Boco Rock Wind Farm Stage Two  
**Application for Modification**  
Response to Submissions

February 2020

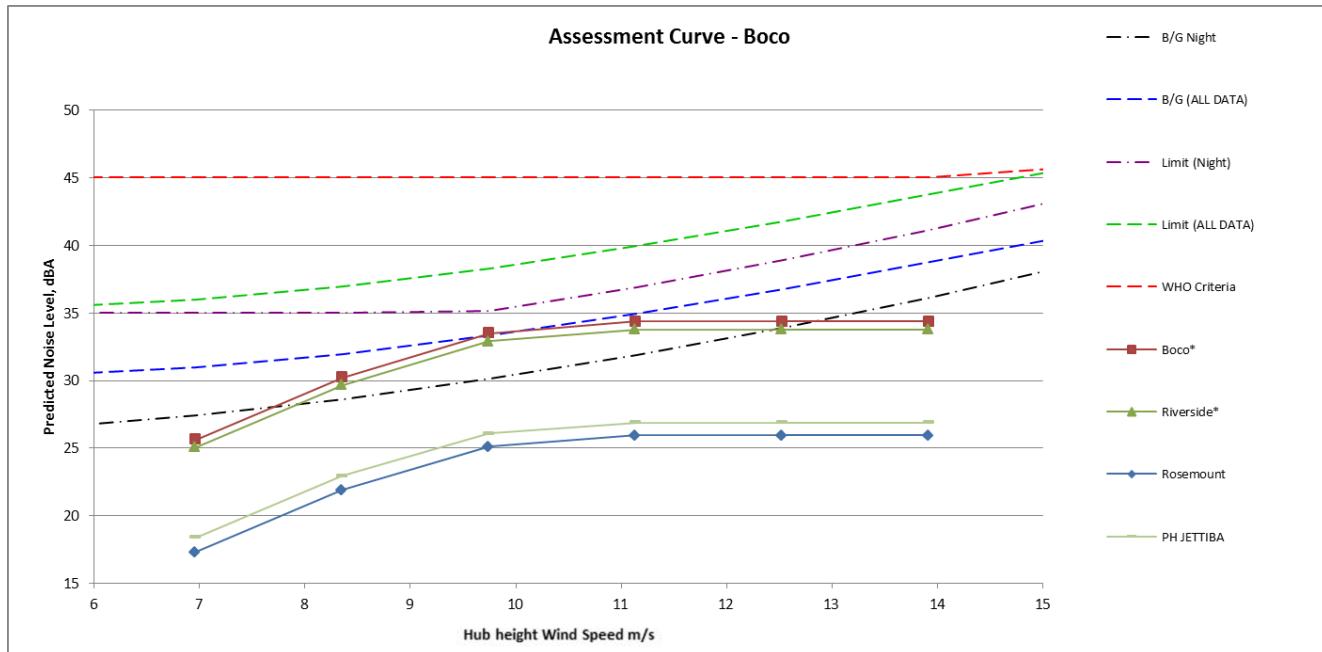
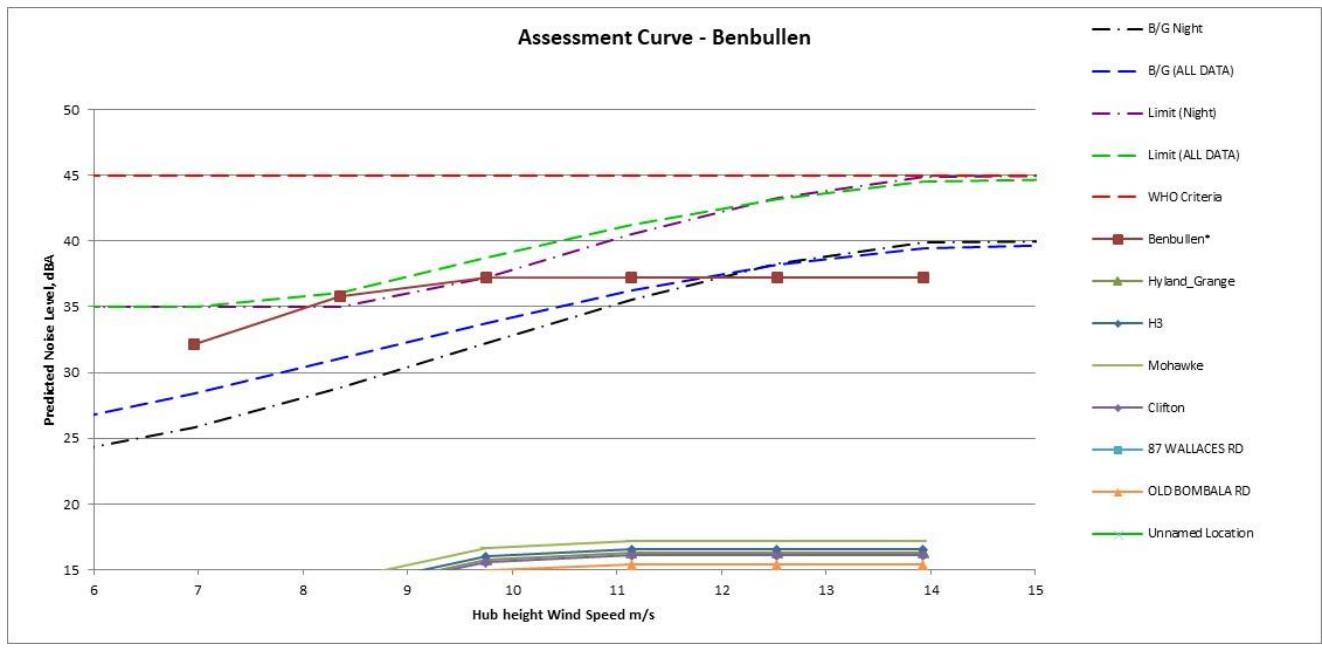
<b>Issue</b>	<ul style="list-style-type: none"> <li>• <i>The predicted noise level increases over Stage 1 for the two different models of WTG considered (V150 and GE 5.3) show unexpected results in light of the sound power levels for these models as shown in Table 9 of the RNA. The GE 5.3 WTG has higher sound power levels at all wind speeds, and yet the predicted noise levels for the GE 5.3 are typically slightly lower in most cases, compared with the V150. The proponent should discuss the predicted WTG noise level increases in Table 11 of the RNA for the two different WTG models.</i></li> </ul>
<b>Response</b>	<p>The reason for the apparent inconsistency between the WTG sound power level differential and the differential changes in received noise level at receptors is a result of the frequency spectrum of each WTG model. Higher frequencies attenuate more readily over distance primarily due to air absorption. A WTG may have a higher sound power level than another WTG model, however, if the spectrum shape of the 'louder' WTG model is more dominant with mid and high frequencies then the received noise at a distant receptor (say 2-4 km away) may well be lower. At closer distances, where the effect of air absorption will not be as significant, the WTG with the highest sound power level will more likely have the highest received noise level.</p> <p>This can be seen in Table 11 of the report where at a close receptor, for example Benbullen, the increase due to Stage 2 shows the GE 5.3 scenario is 0.5 dBA higher compared to the V150 scenario. At most distant receptors the opposite can be the case.</p> <p>Table 9 has been updated and amended to include both 10m AGL as well as hub height (80m AGL) wind speeds.</p>
